STEAMBOAT GONDOLA RELOCATION

STEAMBOAT SPRINGS, CO

No.	Description	Date
1	Addendum #1	3-12-2021
2	Addendum #2	3-28-2021
3	ASI #1	4-19-2021
4	ASI #2	6-7-2021

Project Phase CONSTRUCTION DOCUMENTS
Sheet Title CONCRETE SLAB SLOPE CLARIFICATION
Sheet Number SK-01

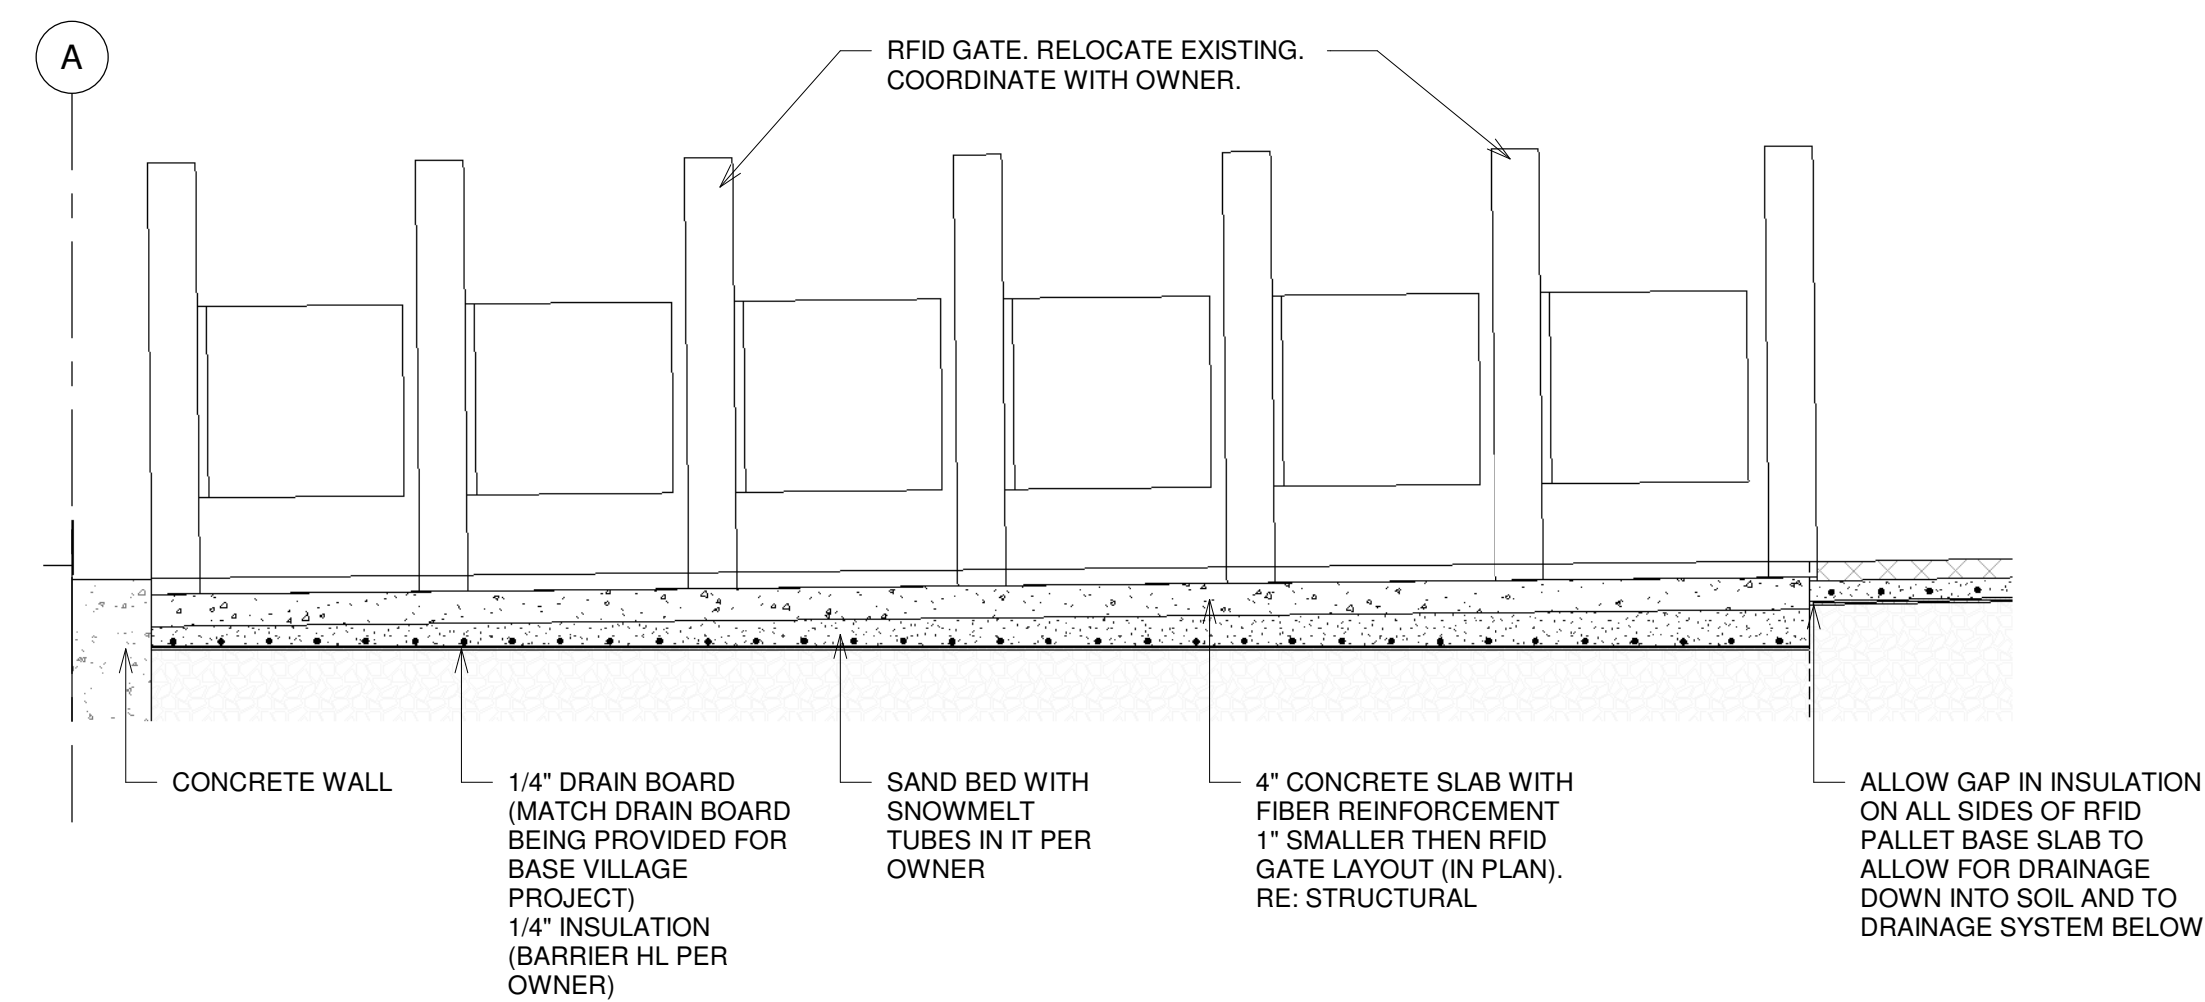
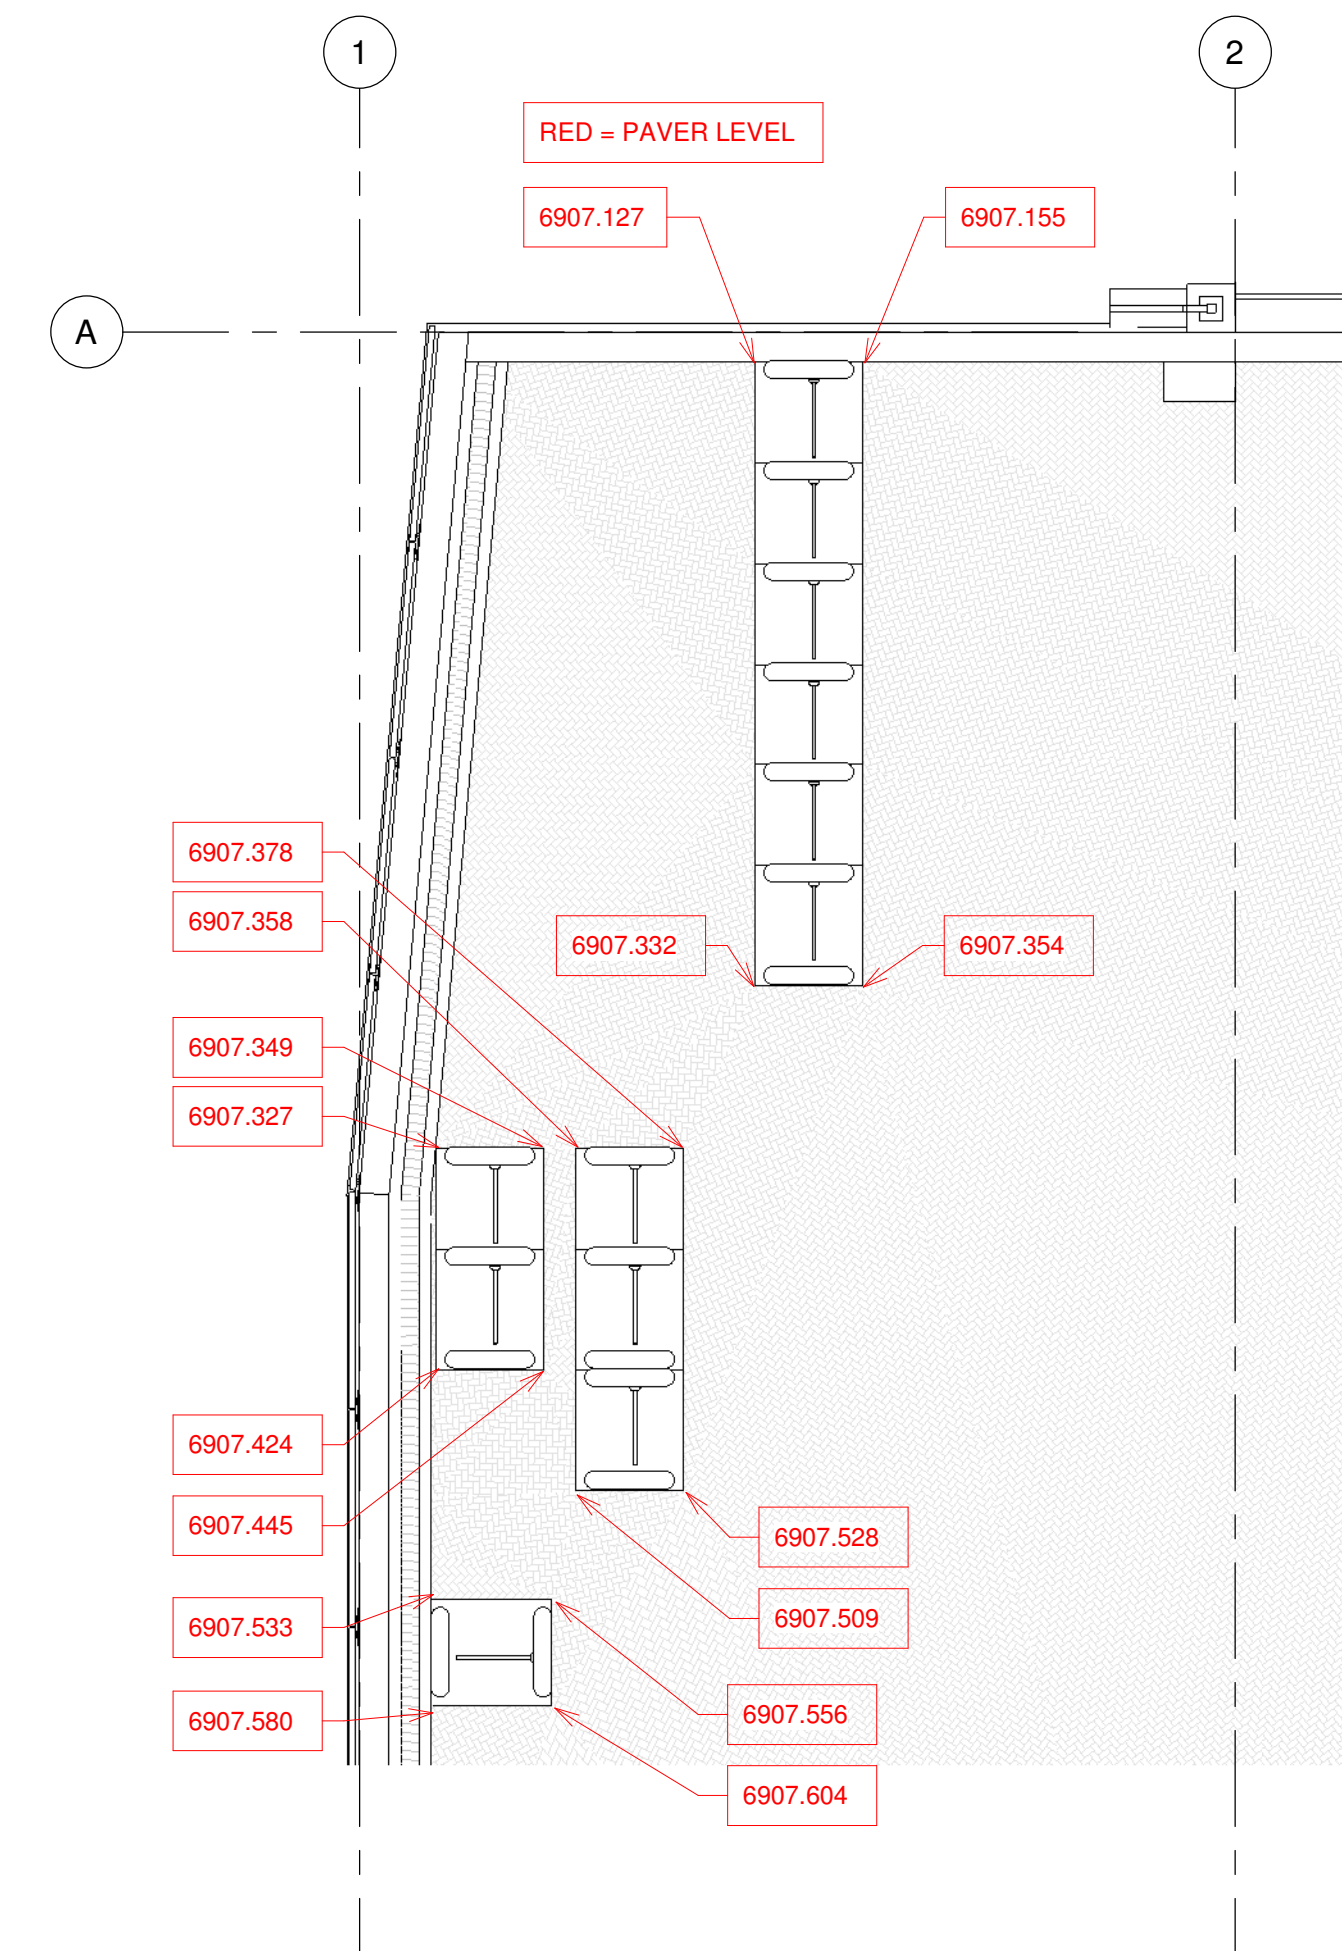
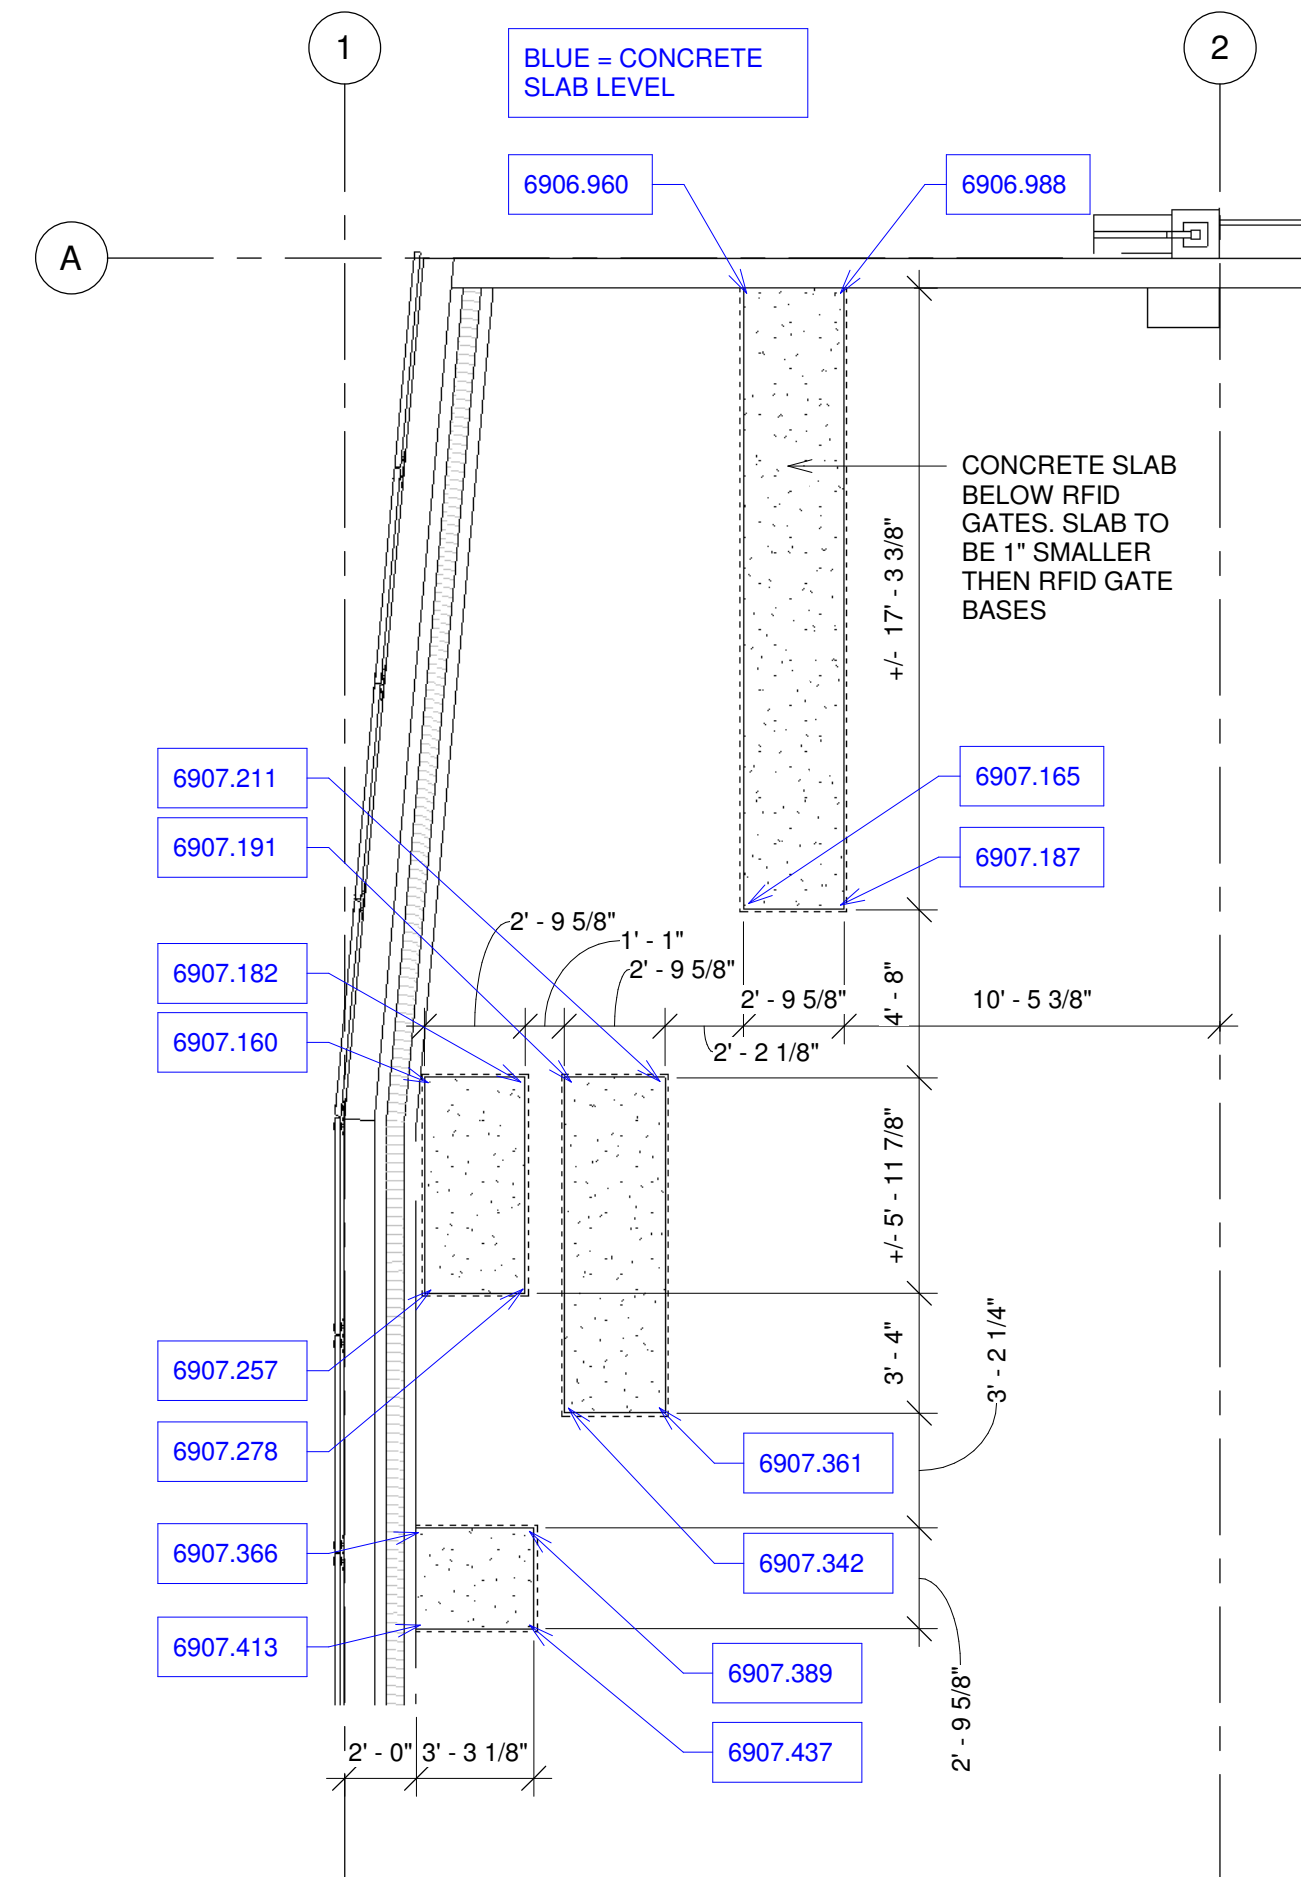
4. PLATFORM PAVERS TO SLOPE AT 2% MAX. RIDF GATES TO BOLT TO CONCRETE SLABS BELOW. ALL GATES ATTACH TO EACH OTHER AND CAN SLOPE MAXIMUM AS A UNIT. SHIM BELONGS TO RIDF GATE PALLETS AND/OR ADJUSTABLE PAVERS MINIMUM. THERE IS NO STEP BETWEEN THE TWO. GUESTS SHOULD WALK ACROSS A FLUSH SURFACE FROM PAVEMENT TO RIDF GATE PALLET AND BACK TO PAVEMENT.
